To:	Addendum #1 Hutchinson Square Park Improvements for Town of Summerville	From:	Josh Lilly, PE 4969 Centre Pointe Drive, Suite 200 North Charleston SC 29418-6952
File:	178420699	Date:	February 13, 2018

Reference: Addendum – Hutchinson Square Park Improvements – Road and Park Bid

The following changes have been made to the bidding and contract documents dated January 24th, 2018:

Project No.	Scale	
178420699		
Drawing No.	Sheet	Revision
C15

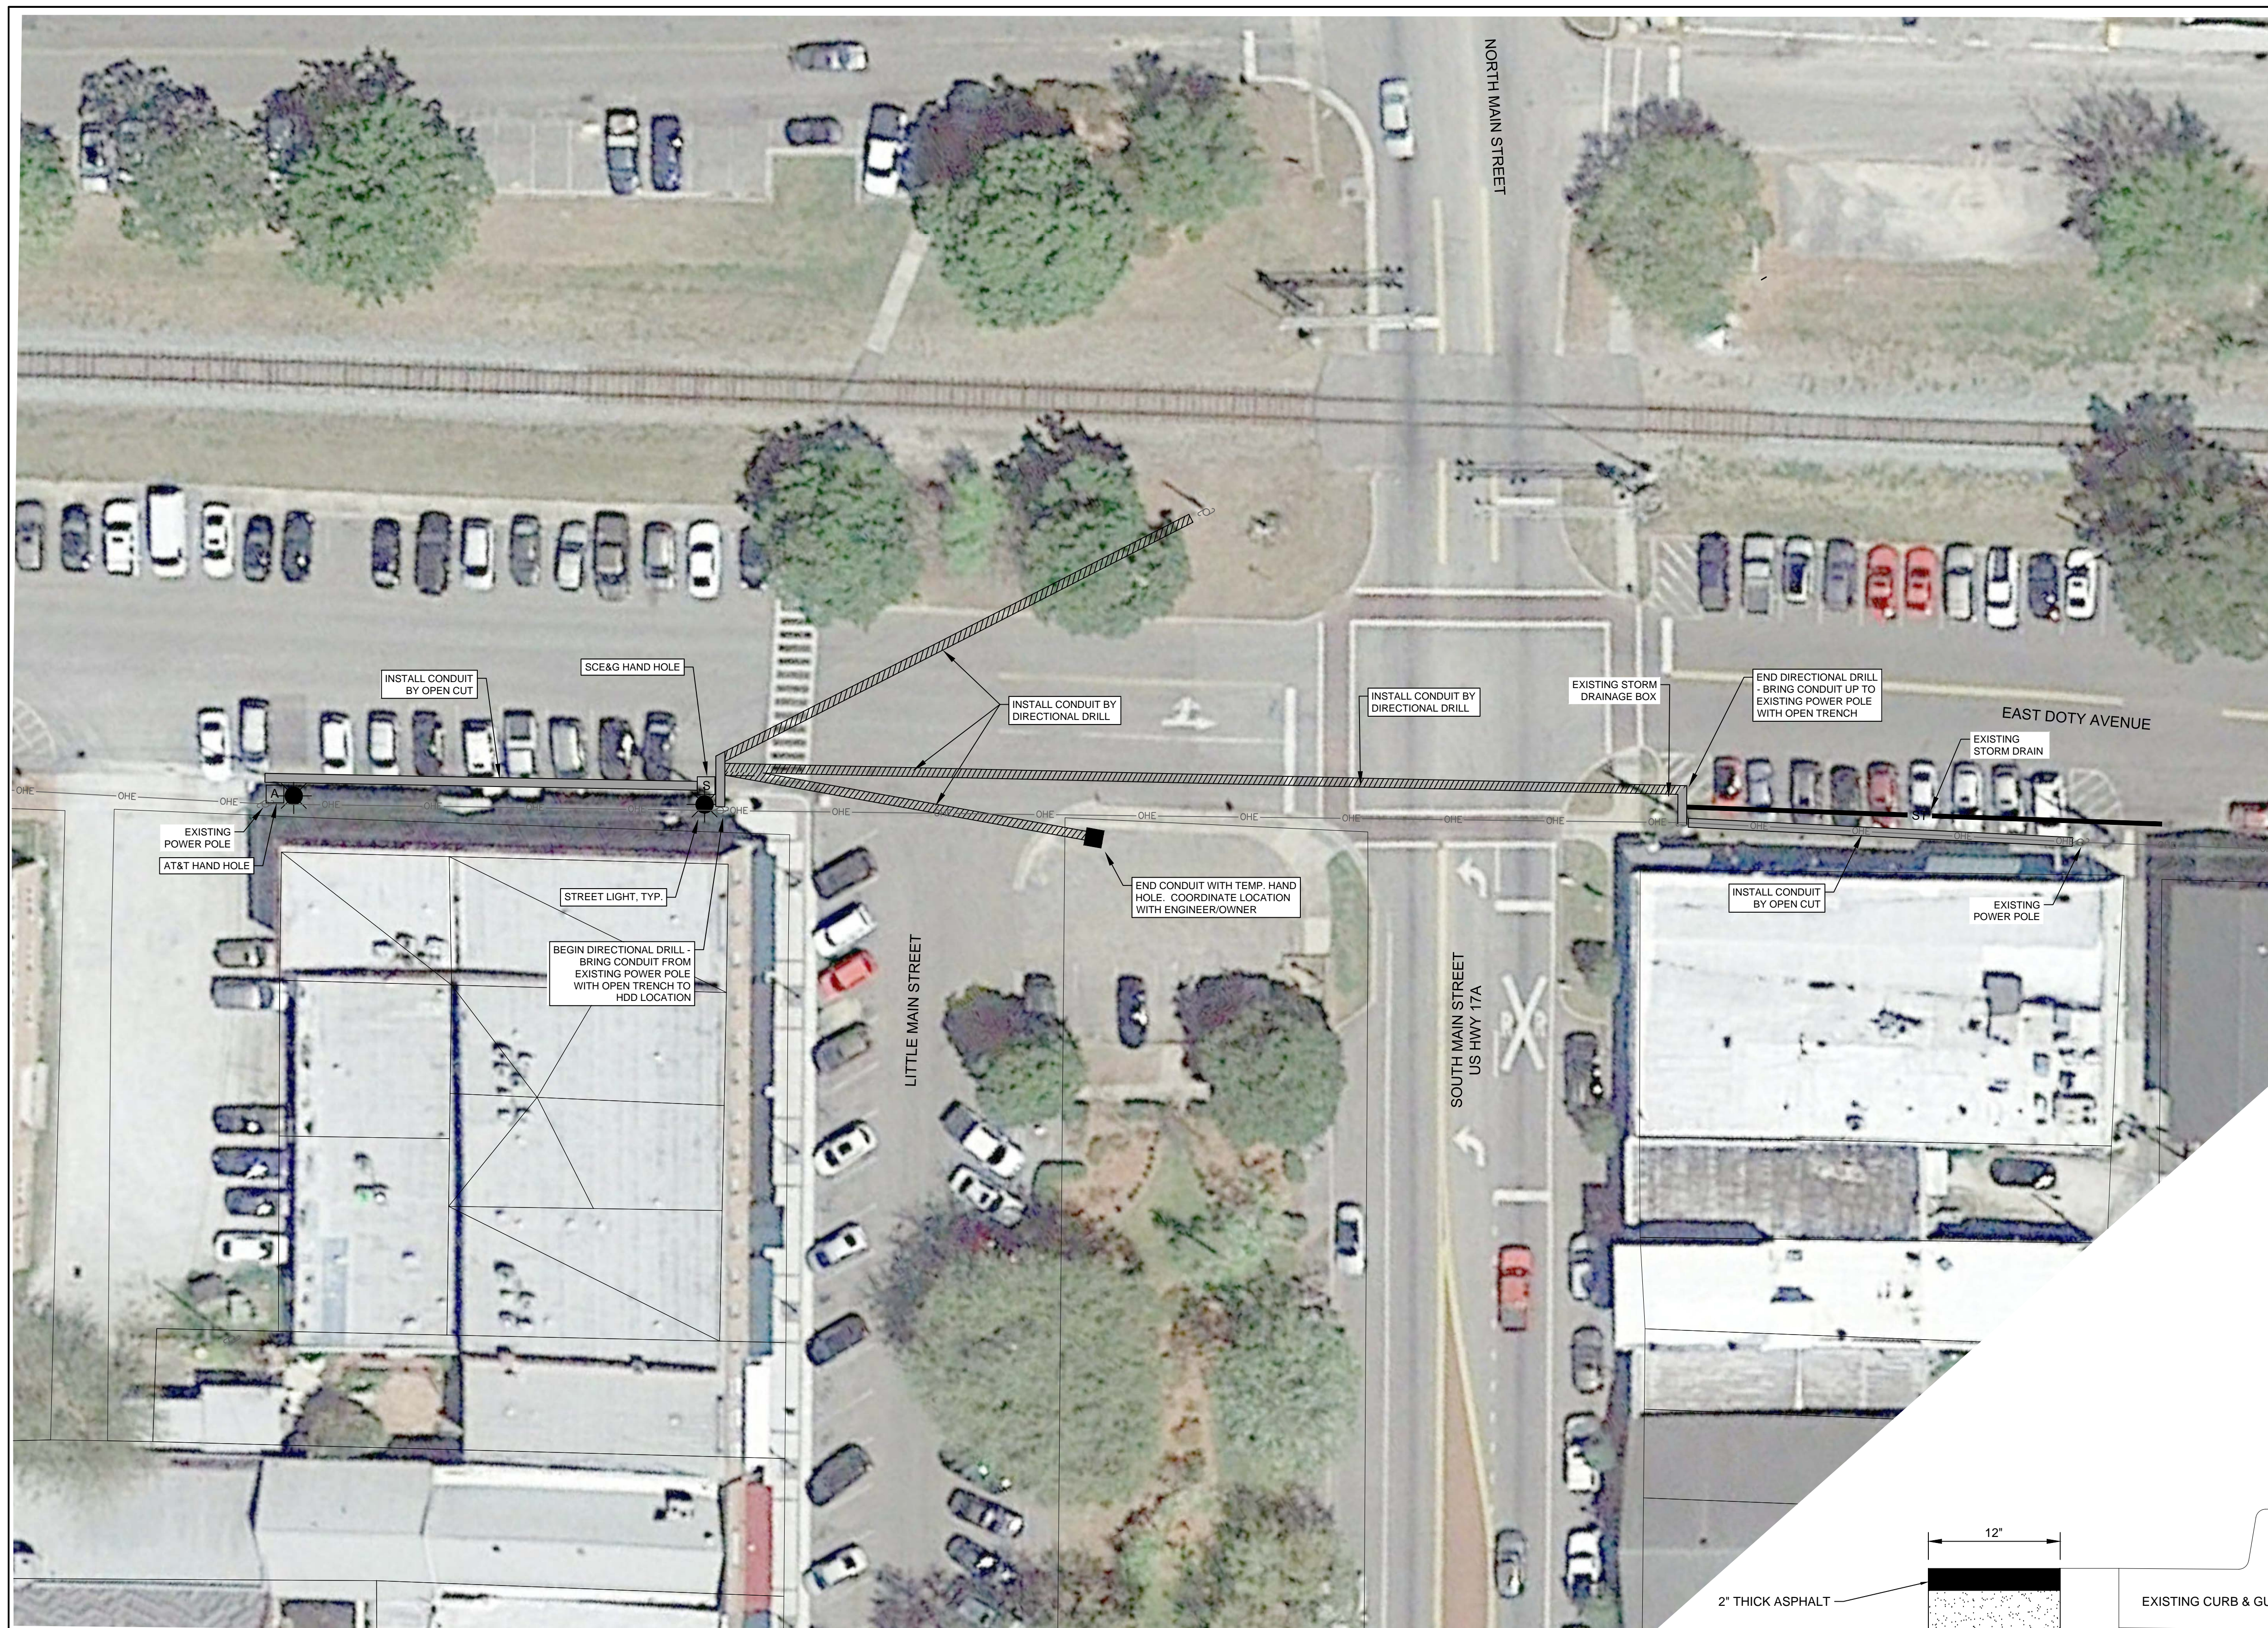
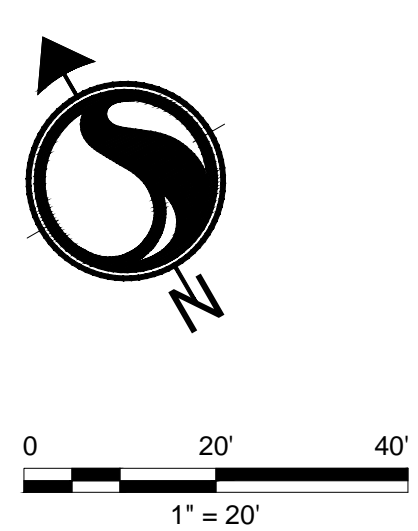
Road Plan Set – Plan Sheets C15 and C16

4. Replace these sheets with the Sheets included in this Addendum

Project No. 178420699	Scale 1" = 20'	Revision
Drawing No. C16	Sheet

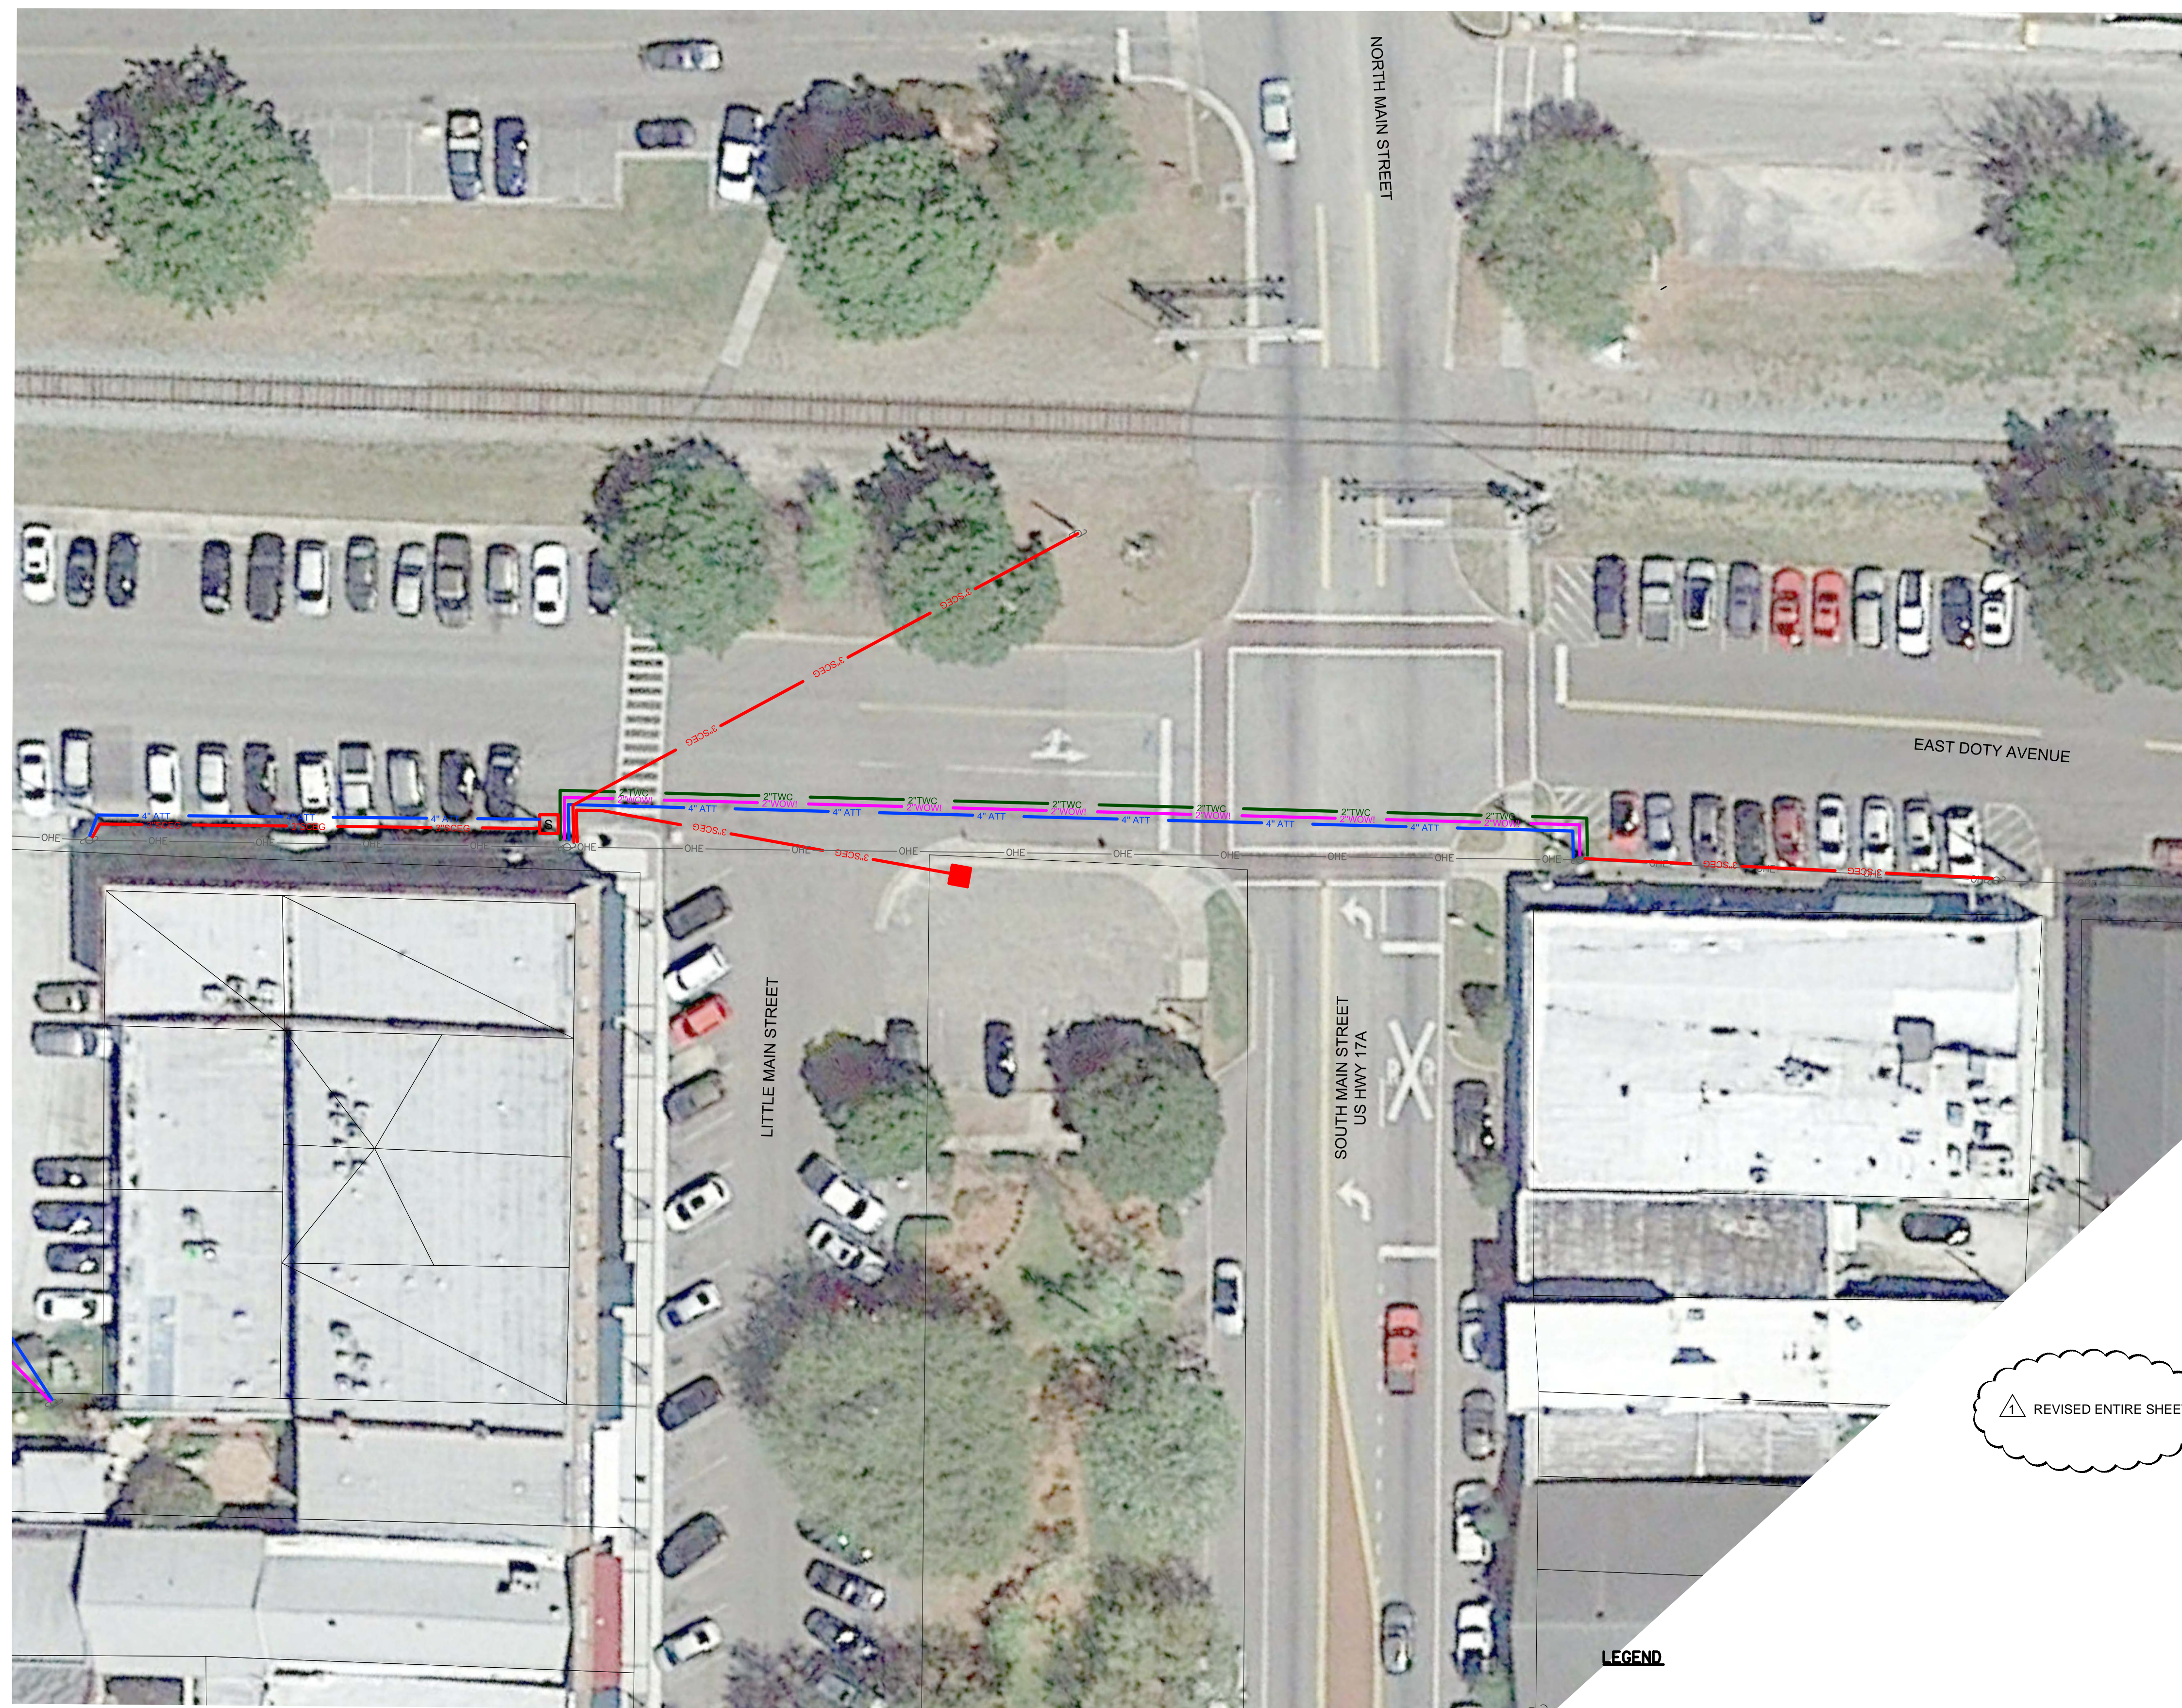
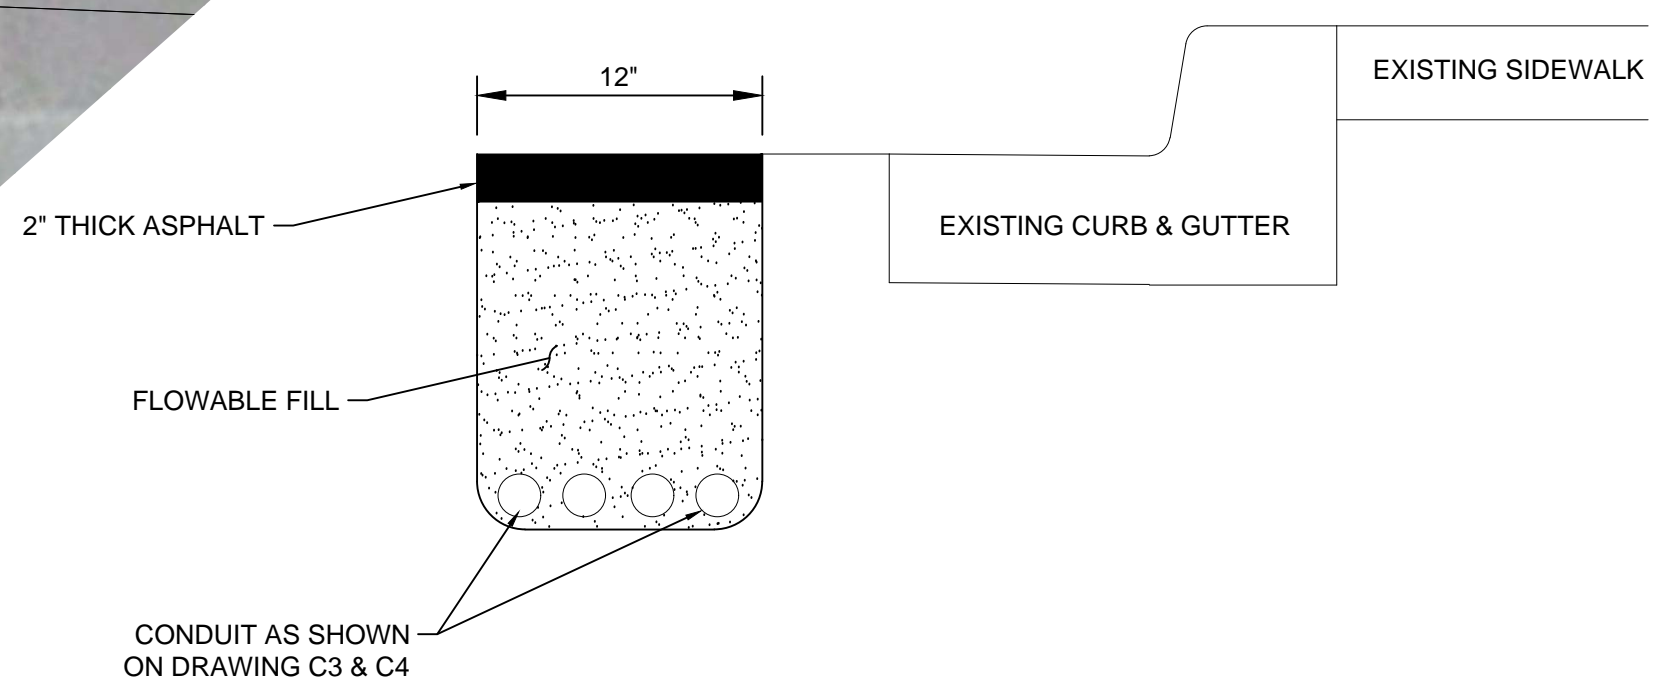
REVISÉ ENTIRE SHEET
